Bulletin Number - BP3 Promenade - Bulletin 08

Project	Steamboat Base Village Redevelopment	Date	08/06/2021
Project Location	Steamboat, Colorado	Architect's Project Number	03.7835.000
Owner/Client	Alterra Mountain Company / East West Partners	File	6BL This is page 1 of 2
To	Saunders Construction Inc.	Attention	Bryan Sculthorpe
Address	86 Inverness Place North		
City	Englewood	State	CO Zip Code 80112
Delivered via:	<input type="checkbox"/> Messenger <input type="checkbox"/> Hand carried <input type="checkbox"/> Facsimile <input type="checkbox"/> Express <input type="checkbox"/> Pick-up <input type="checkbox"/> E-mail Address <input type="checkbox"/> Mail <input type="checkbox"/> UPS <input checked="" type="checkbox"/> Website Address BIM360

Description of Changes

① (DE) SITE POWER PEDESTAL - 36" QUAD, EPO, FIREPLACE
NO SCALE

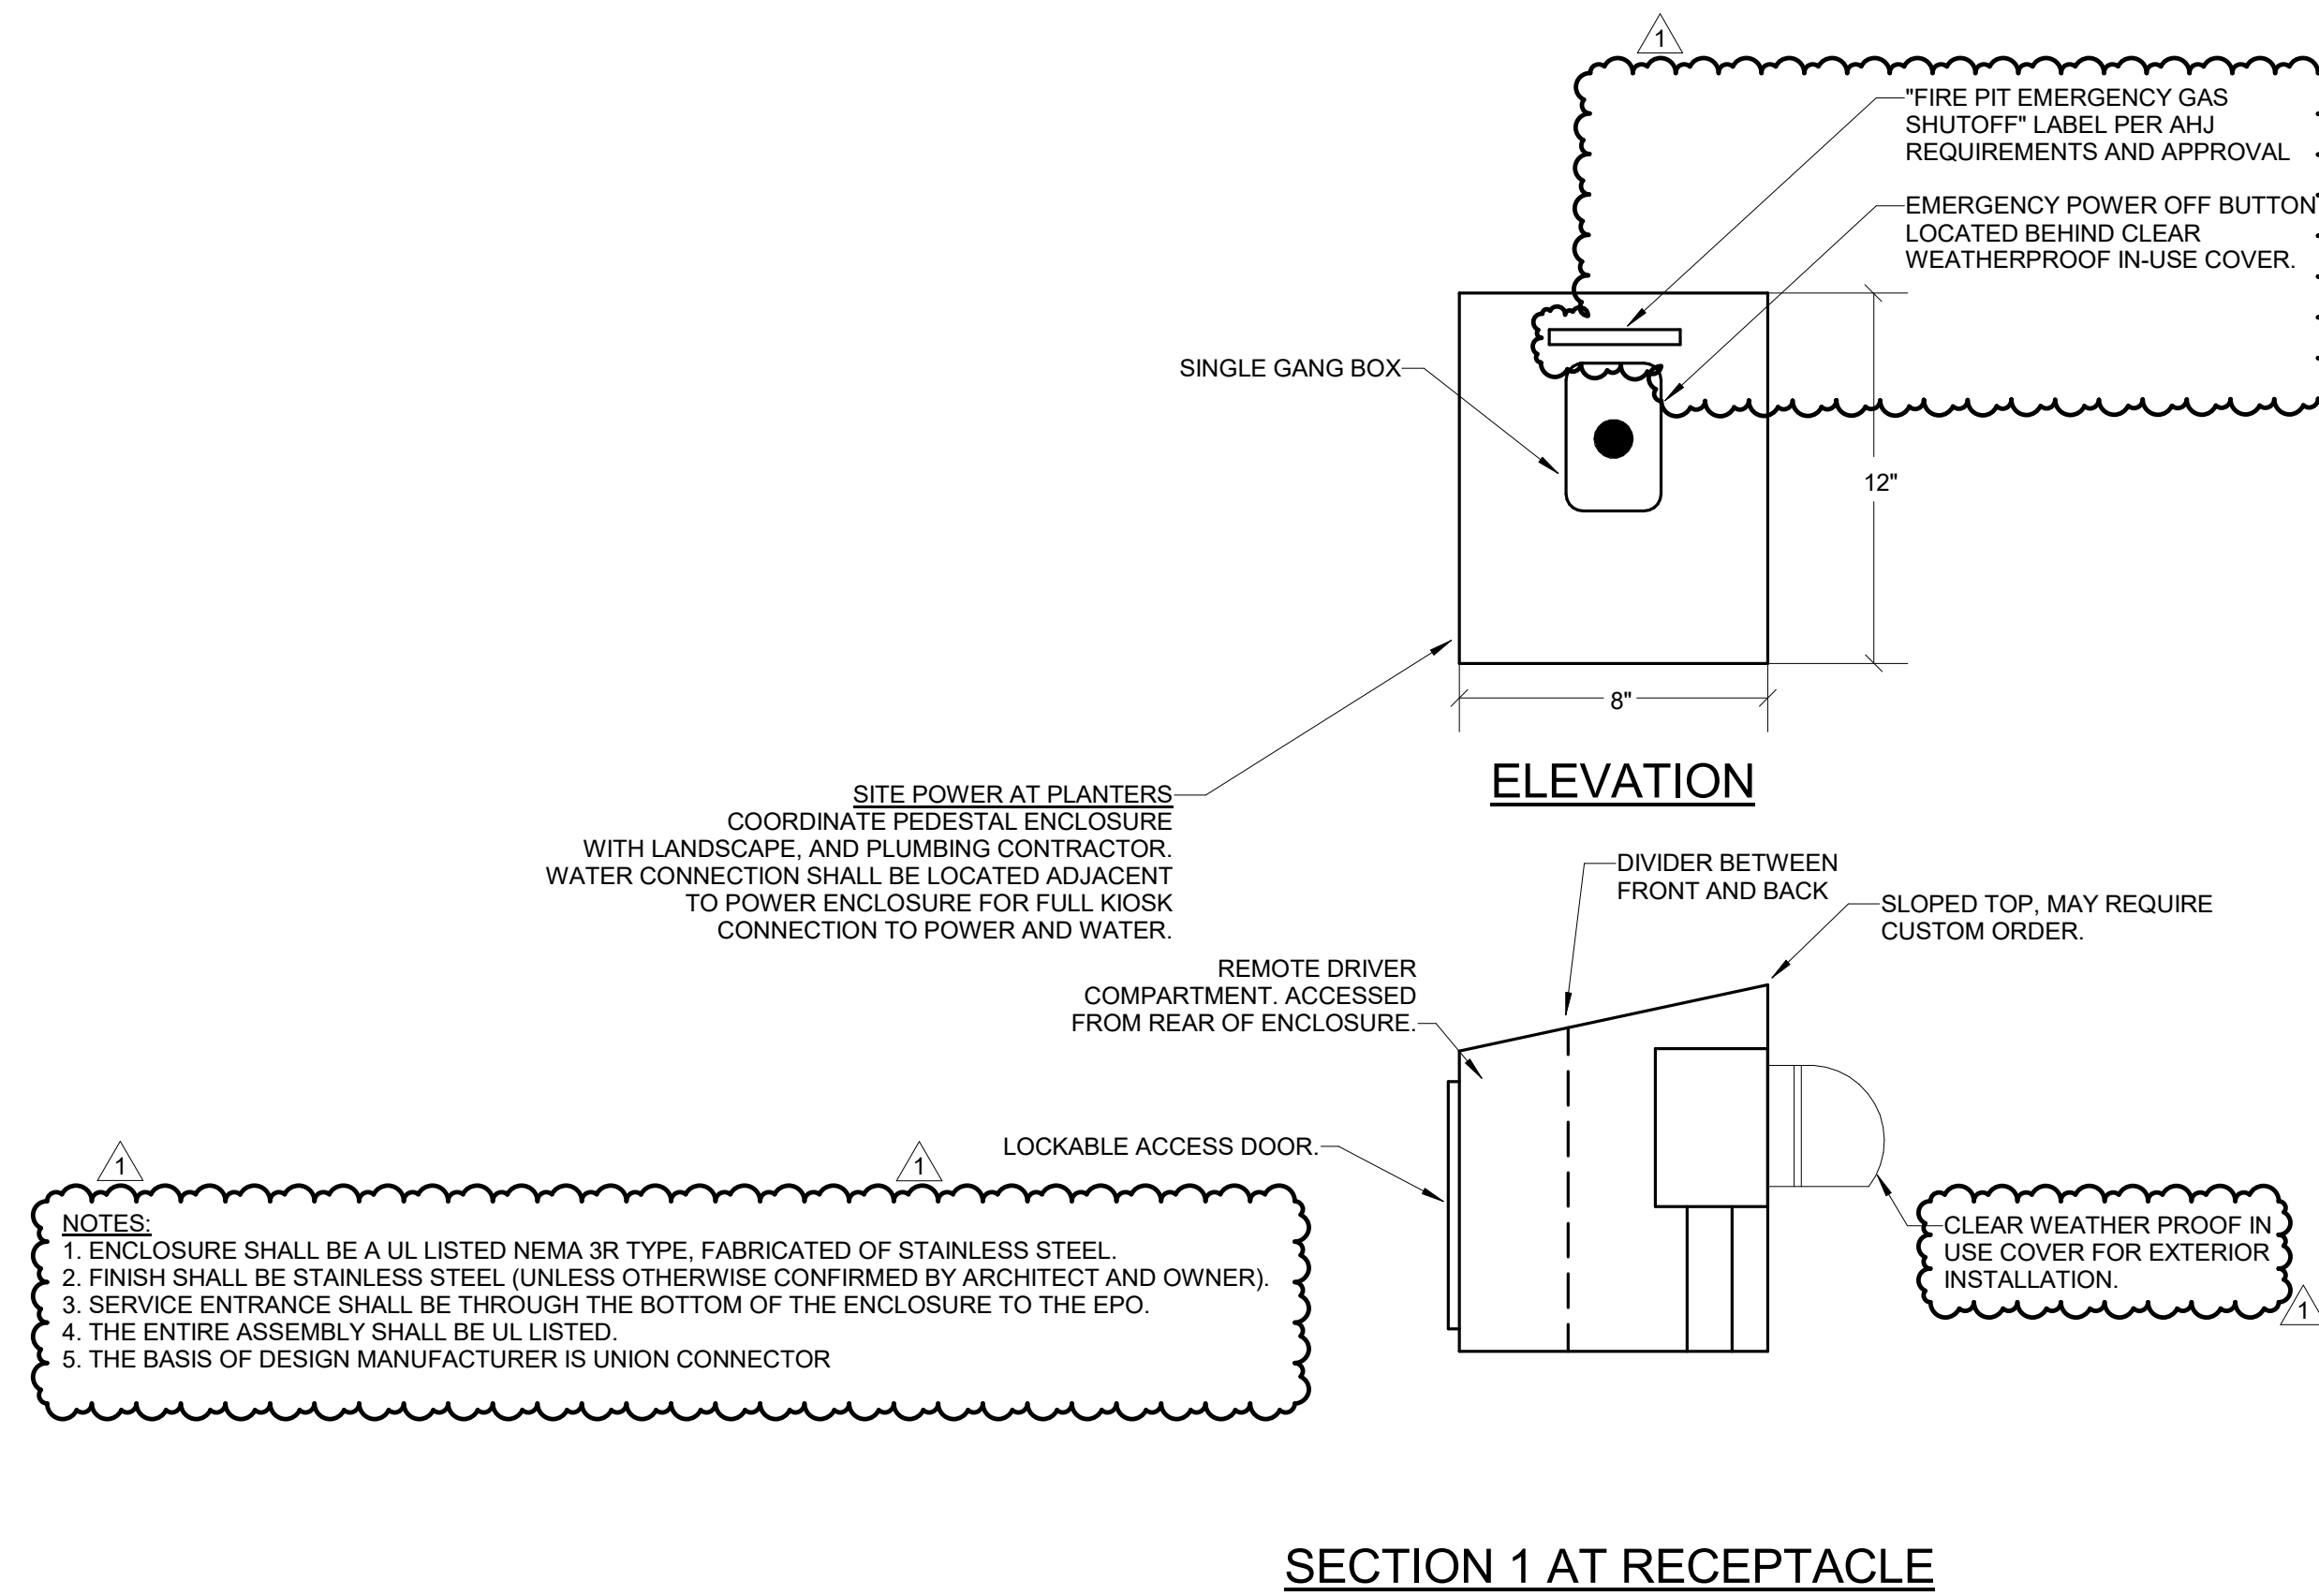
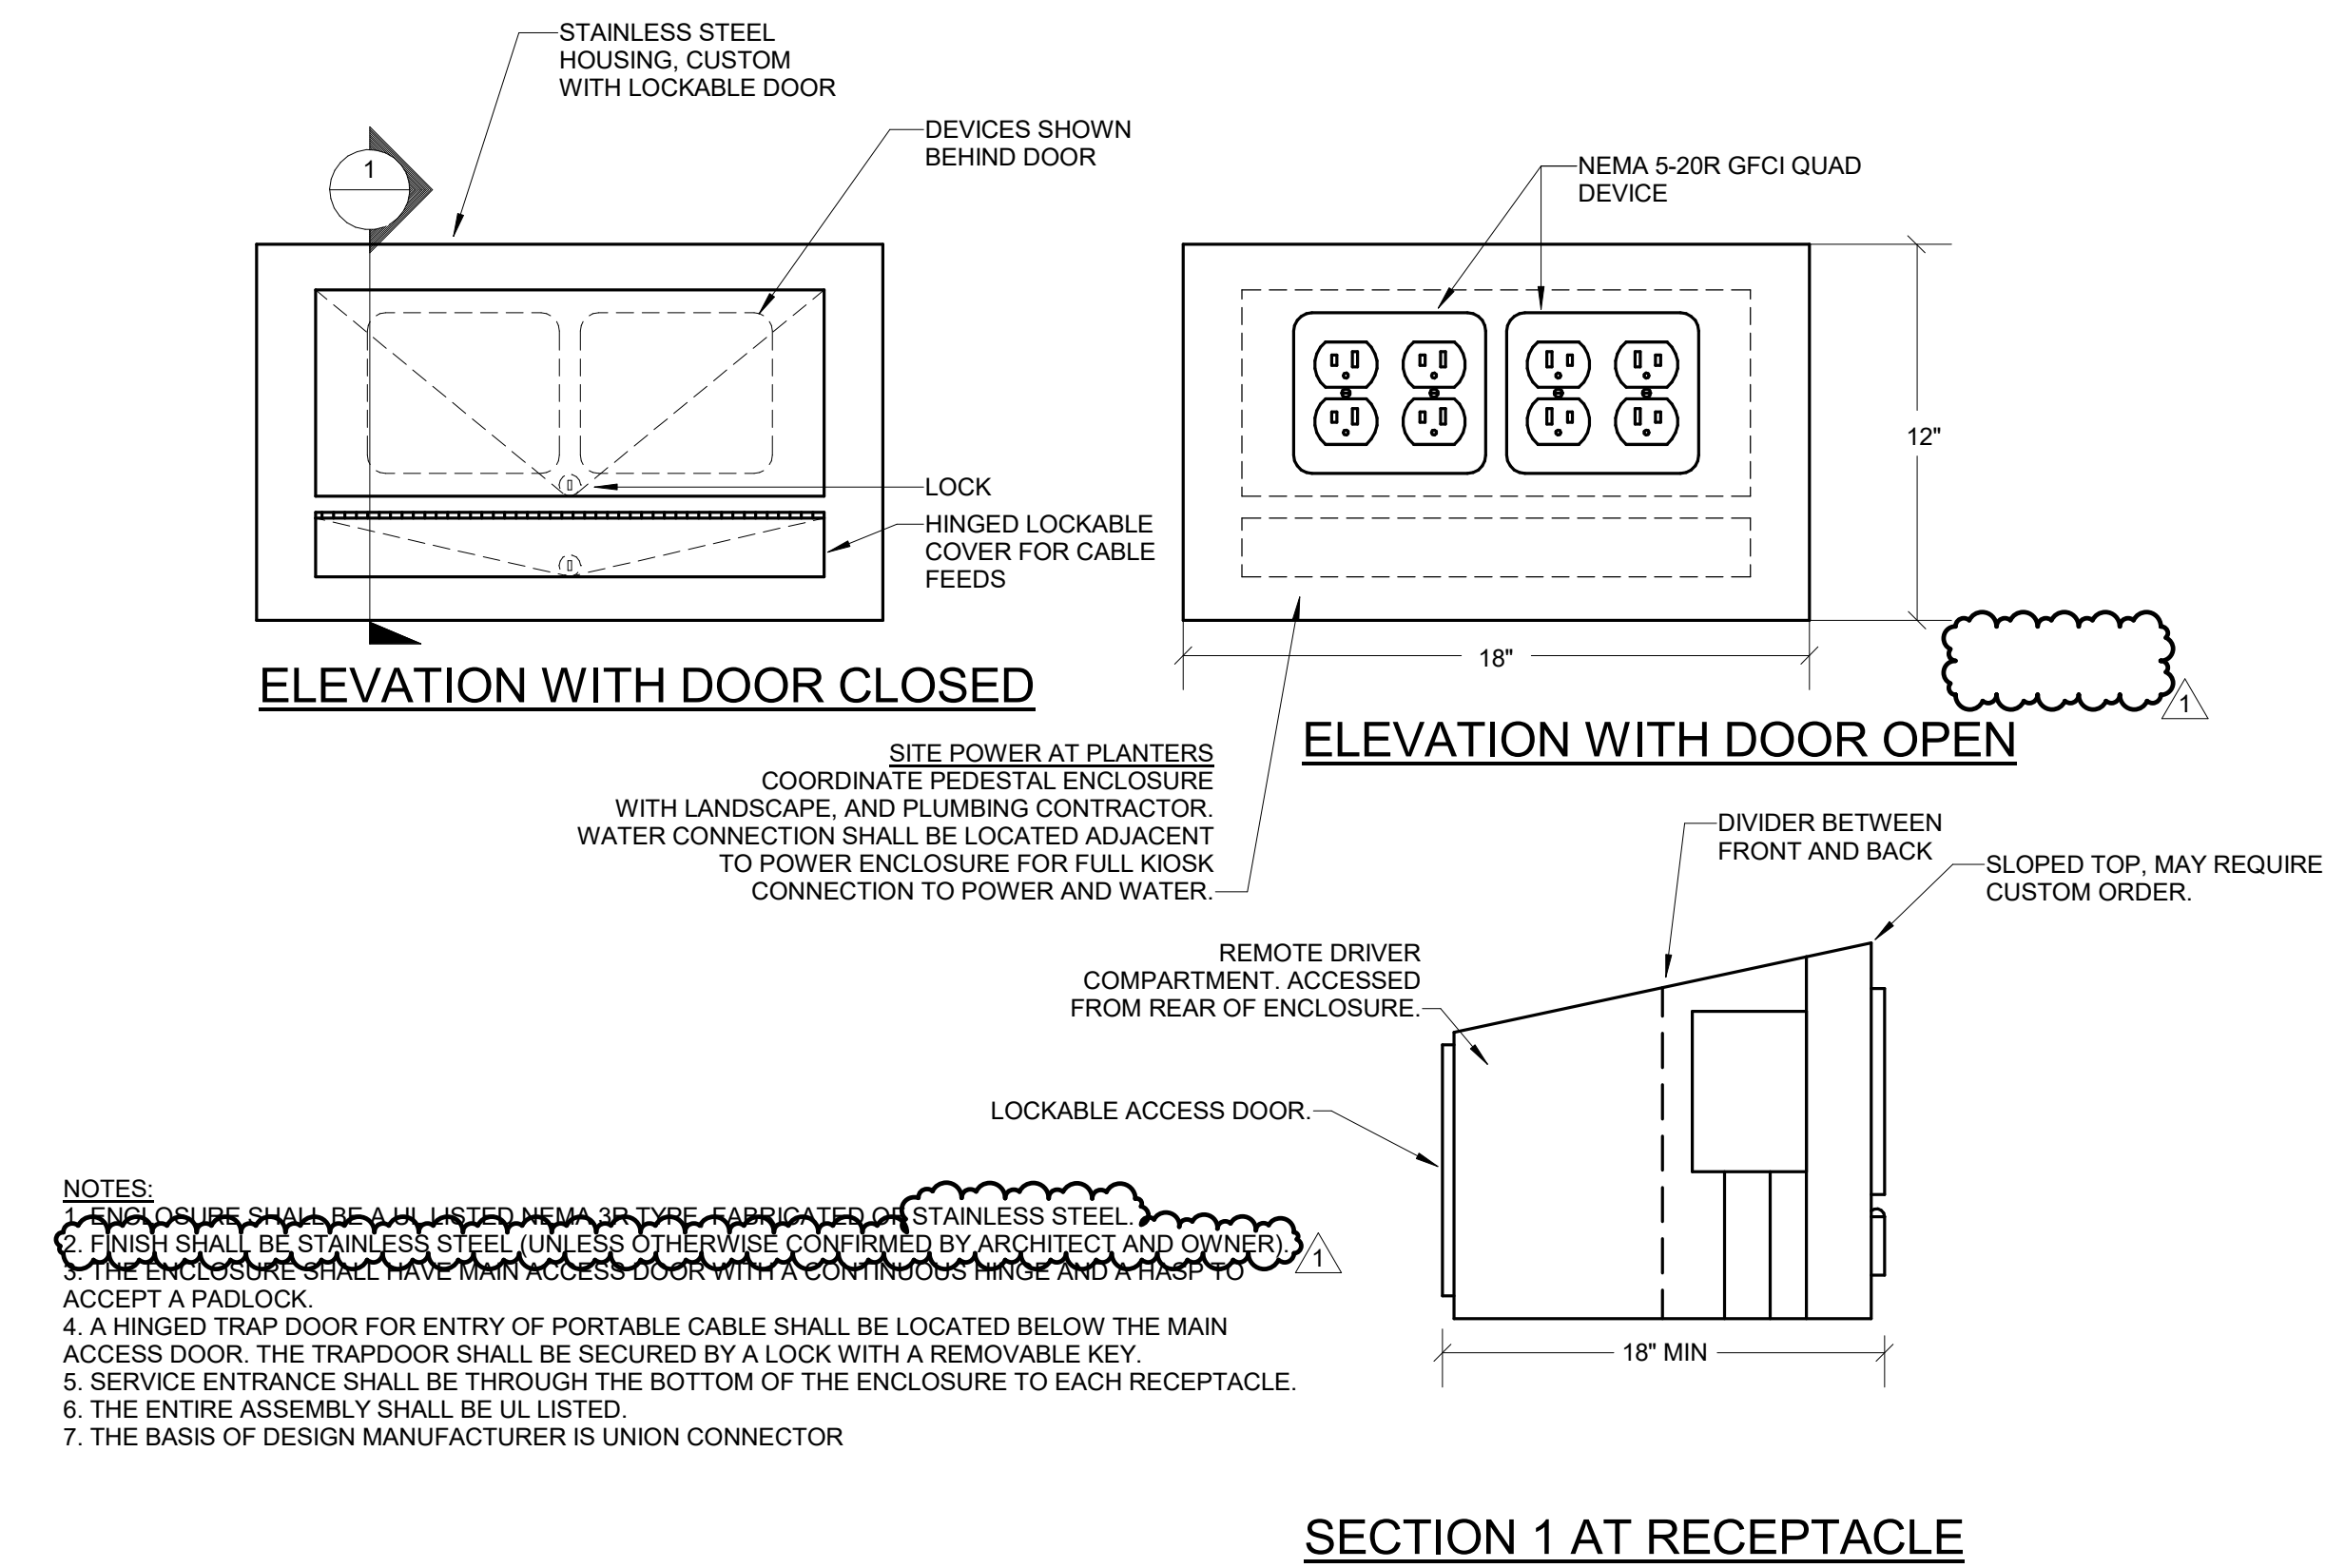
- b. Modified lighting controls matrix to align with design intent and conversations with lighting controls rep.
- 34. 1A-E8.002
 - a. Modified plaza details for added clarity to design intent of plaza pedestals and fire pit EPO buttons.
